Document ID# 1556711
2004 Cadillac CTS

No Start, Inaccurate Fuel Gauge (Replace Sender Fuel Feed (Transfer) Pipe and Inspect Primary Module Transfer (Jet) Pump) #04-06-04-077 - (Oct 19, 2004)

2004-2005 Cadillac CTS, CTS-V, SRX

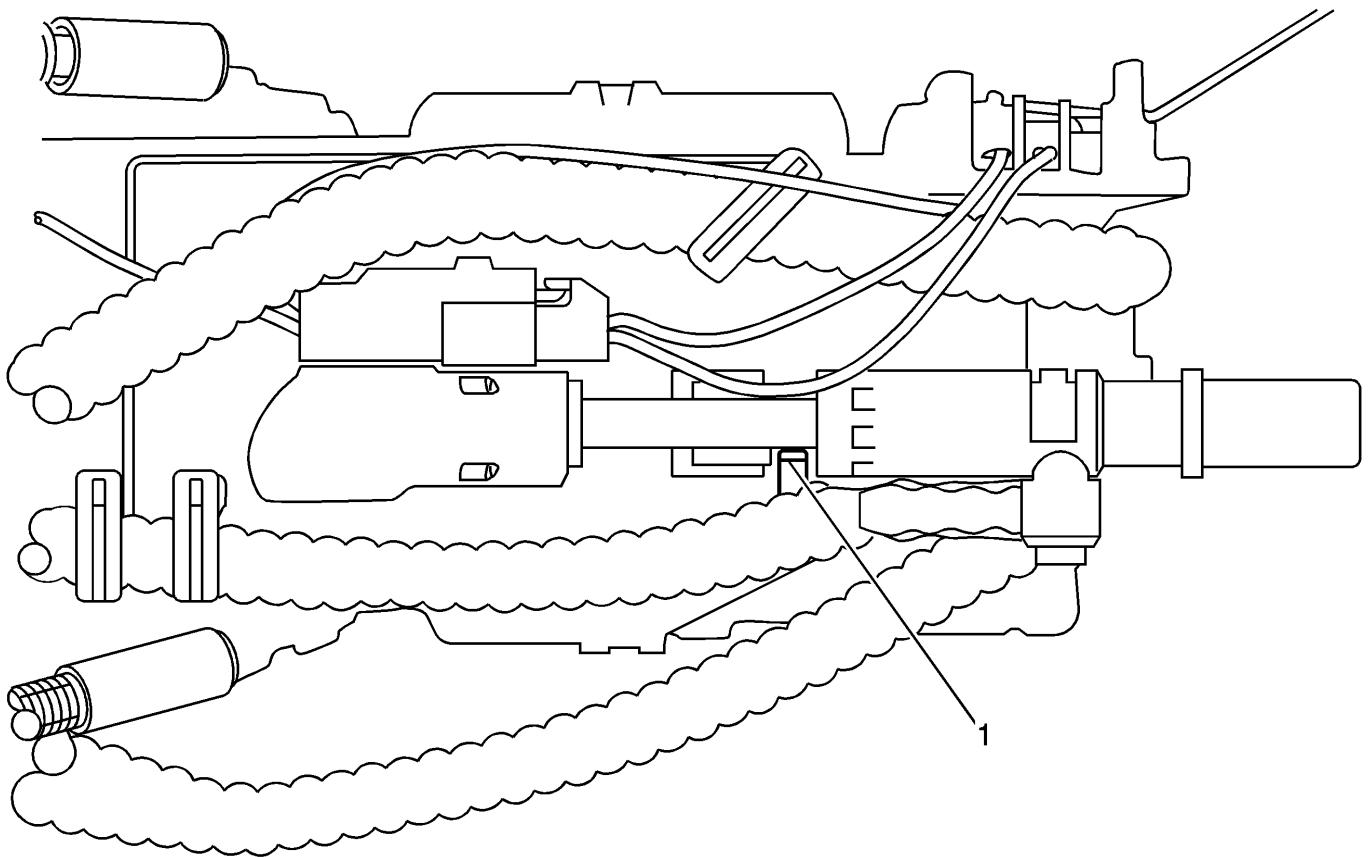
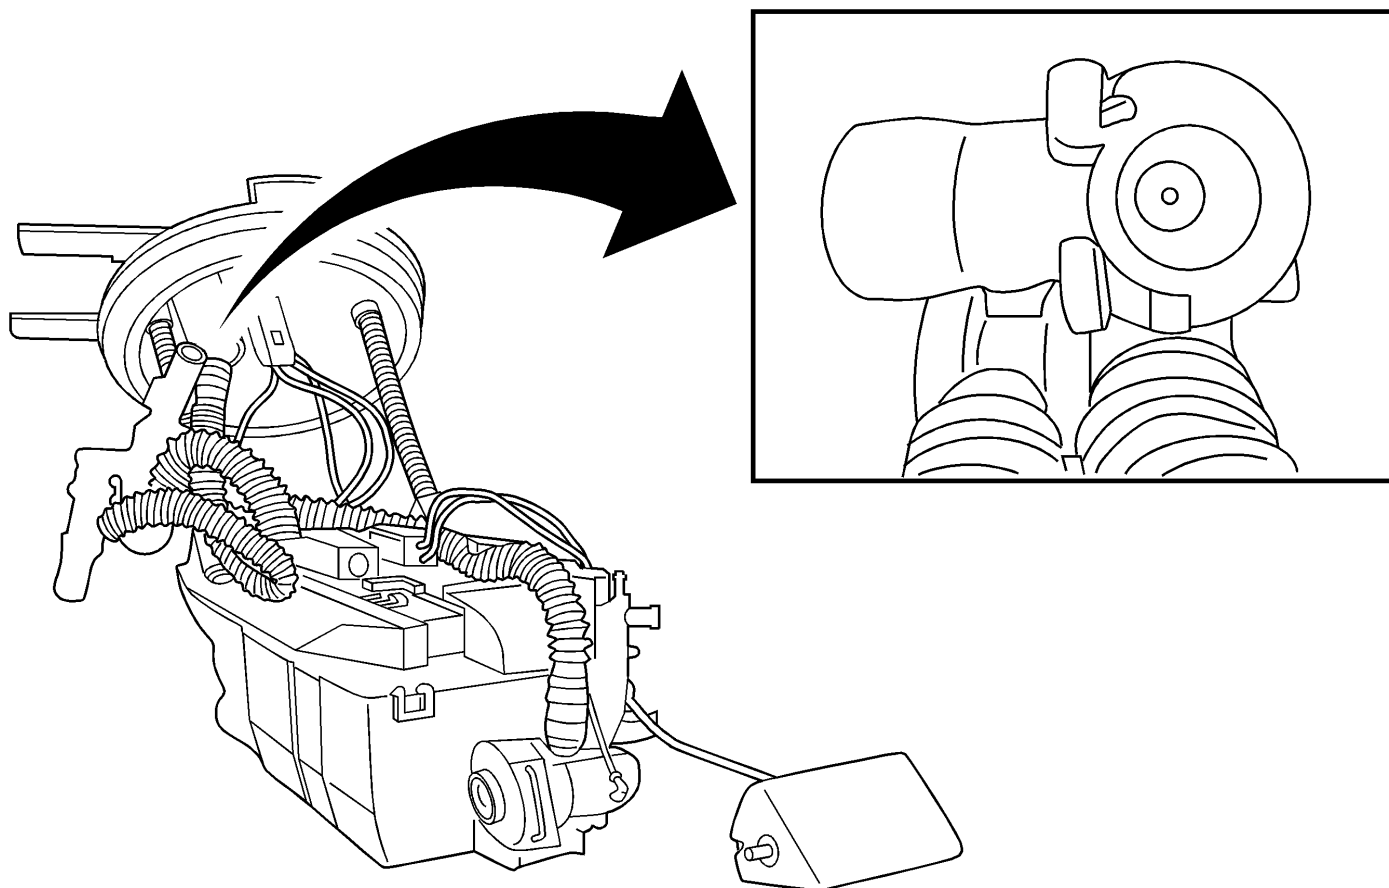
The cause of this condition may be insufficient fuel transfer from the left fuel reservoir to the right fuel reservoir. The poor fuel transfer may be the result of one or a combination of both the following:

- The sender fuel feed (transfer) pipe has two anti-siphon holes in the middle of the pipe which are too large.
- A clogged/restricted transfer (jet) pump -- part of the RH primary fuel tank module.

Replace the sender fuel feed (transfer) pipe with P/N 10388380. This new pipe has one anti-siphon hole. Also, inspect the RH primary fuel tank module for a clogged/restricted transfer (jet) pump. Use the procedure listed below:

12. On the RH primary fuel tank module, inspect the jet pump by releasing the tab (1) securing the pump to the module. Position the jet pump with light at the rear and look through the tube. The hole should be clear from debris and not black in color. If the jet pump shows signs of being plugged, replace the RH primary fuel tank module.
13. Install the RH primary fuel tank module into the fuel tank. Refer to the Primary Fuel Tank Module Replacement procedure in the Engine Controls sub-section of the Service Manual.
